Bryant Development and Review Committee Meeting

Date: July 31, 2025 - **Time:** 9:00 AM

6. New Beginnings - Hwy 5 and Midland Rd

PLE - Requesting Site Plan Approval

SHEET NUMBER:
C1.6

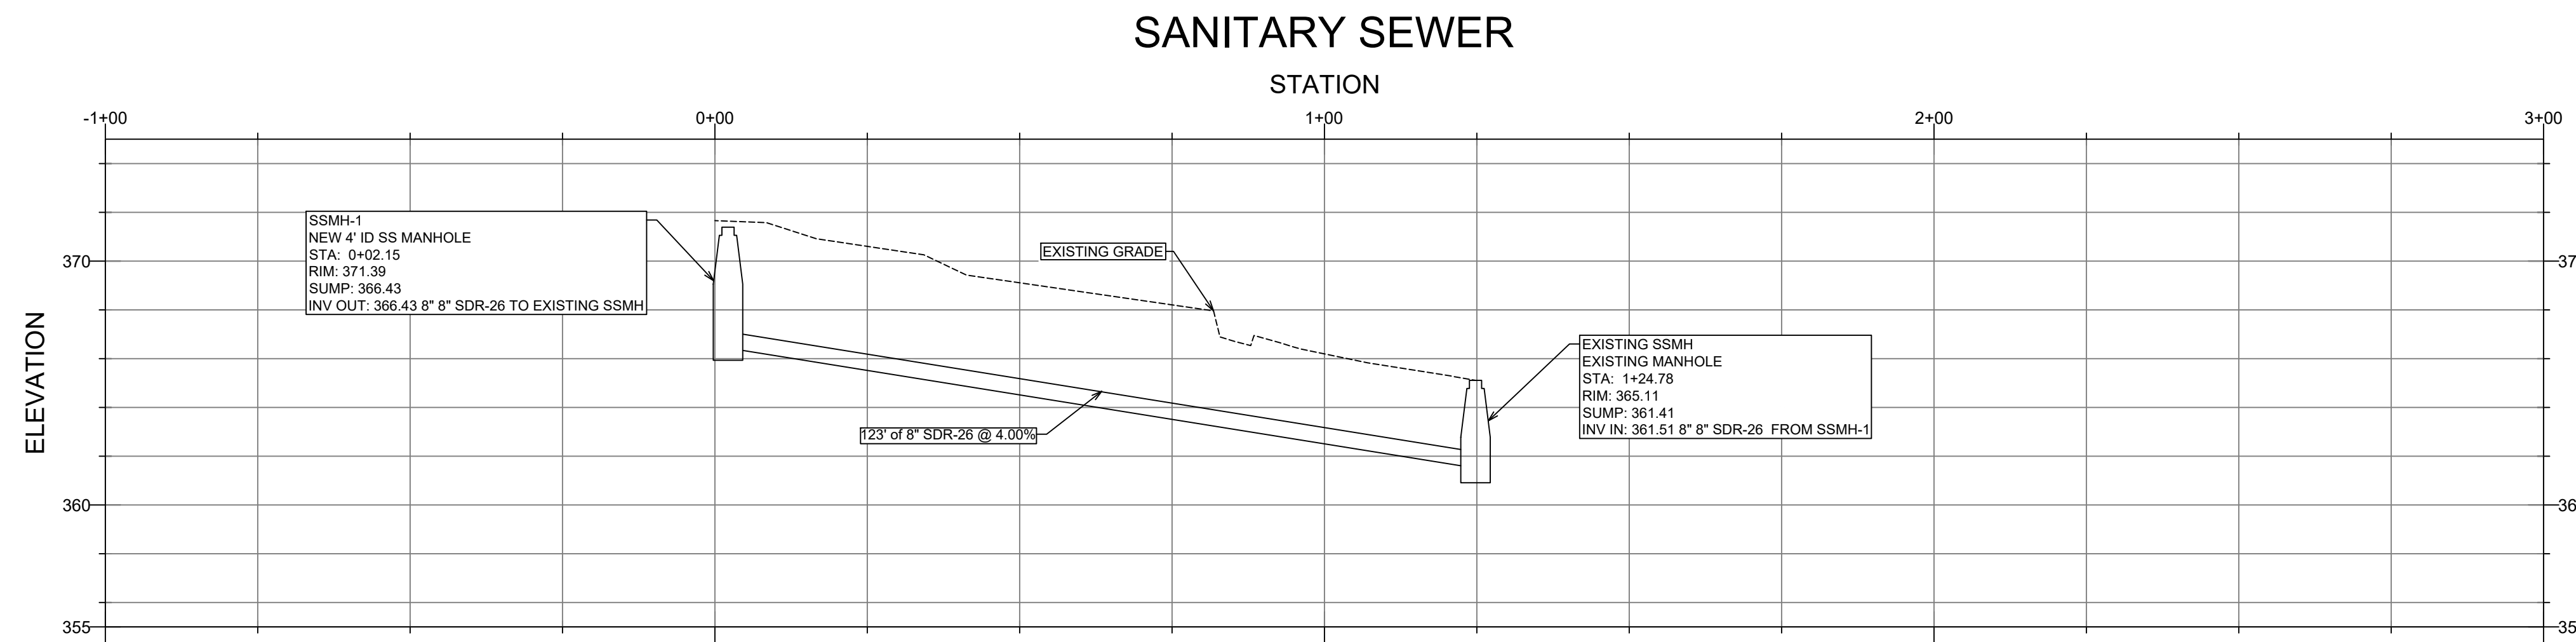
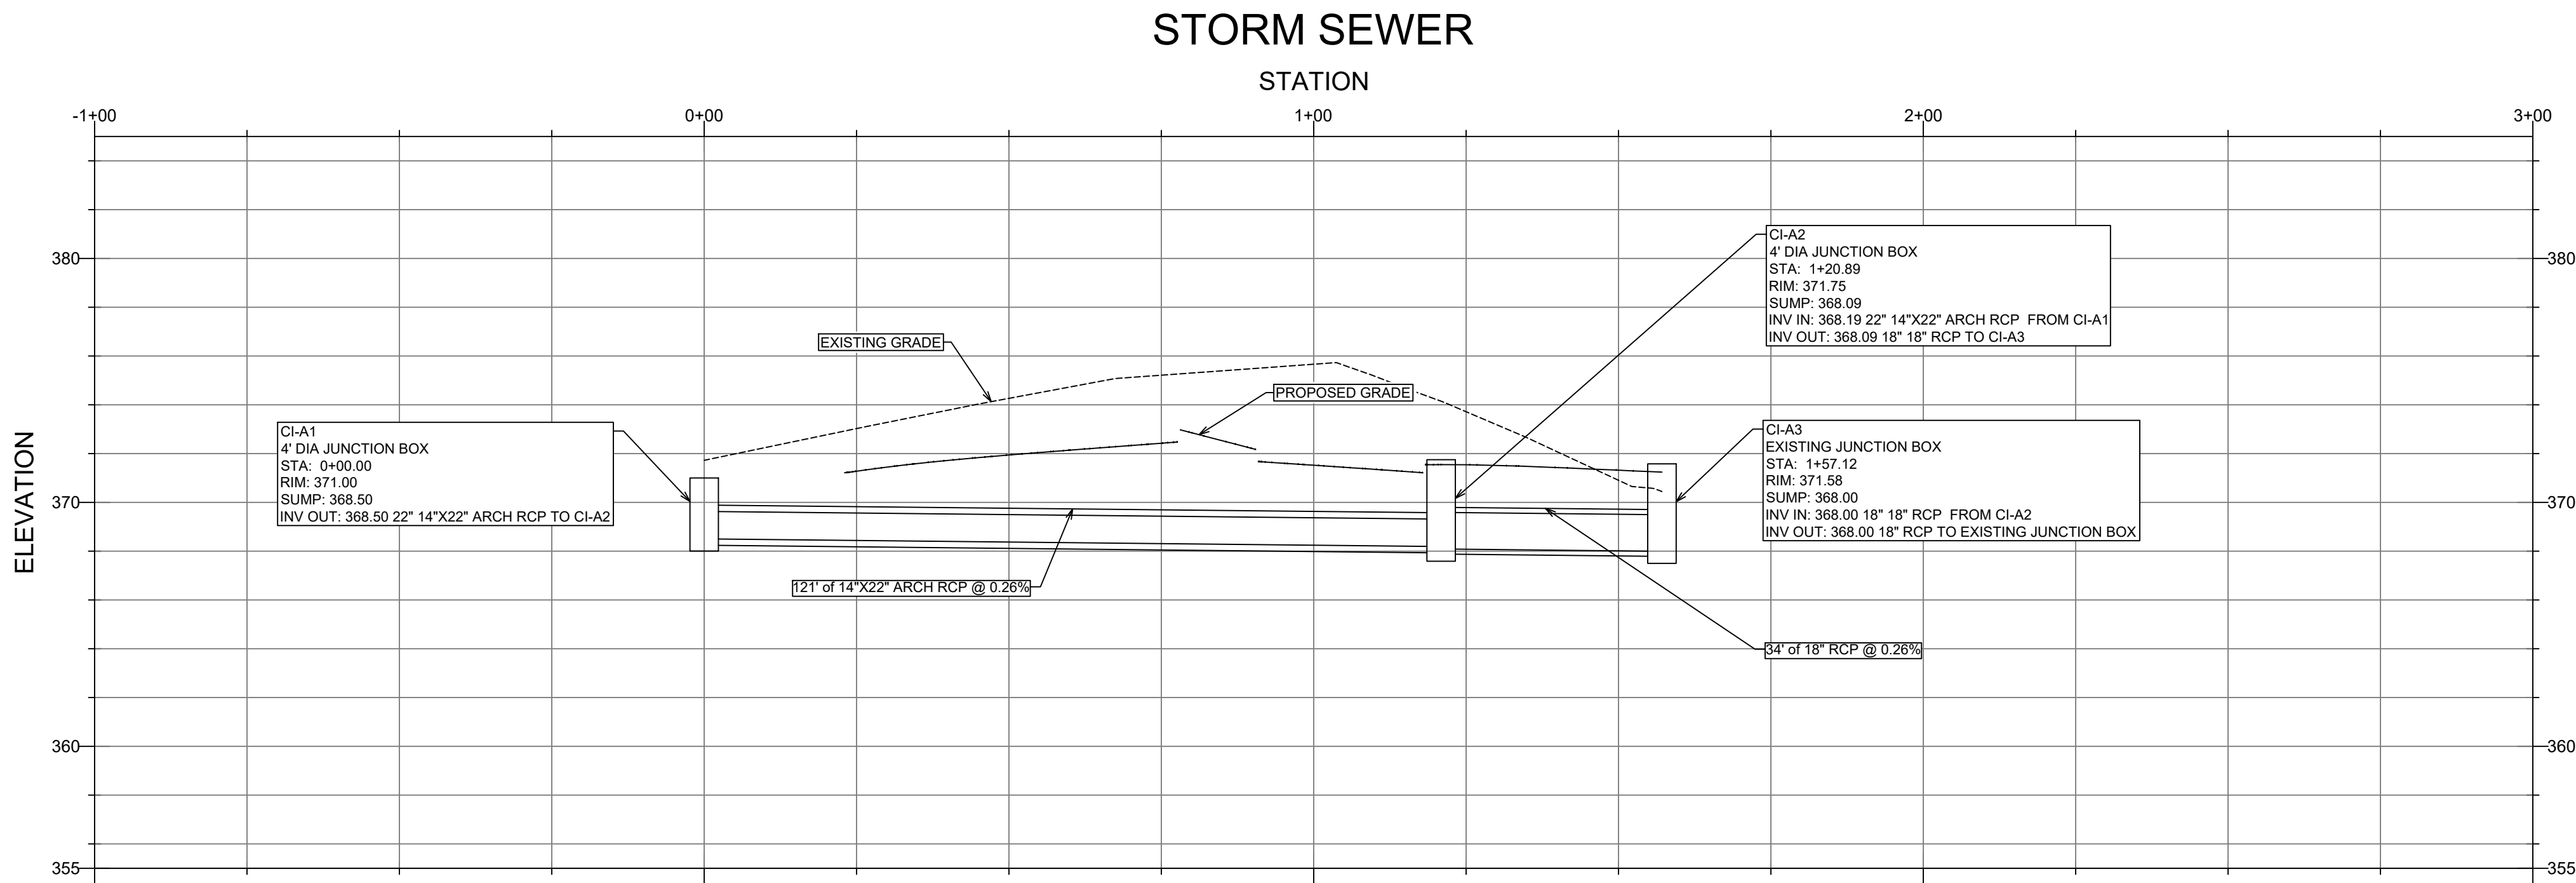
- Addressed in earlier comment.
 - j. Label dumpster
 - Corrected
8. Drawing C1.6
- a. Where does existing junction box CA3 drain?
 - The entire existing storm system can be seen on sheet C1.1. The two new inlets drain to the existing storm system installed under the Seminary project.

- b. Show storm drainage information on Drawing C1.5, not as part of the utility plan.
 - Corrected
 - c. Where does the existing sanitary sewer drain?

- Existing sanitary sewer drains through the Seminary extension to the main trunk line running to the adjacent SS pump station. Overall SS routing can be seen on C1.1
- d. Show the existing sanitary sewer pipelines and manholes
 - Corrected.
- e. Show all existing utilities
 - Corrected.
- 9. Drawing C1.10 & C.1.11
 - a. Explain how the basins show reflect runoff that contributes to discharge from the site.
 - Basins have been completely revised from last submittal.
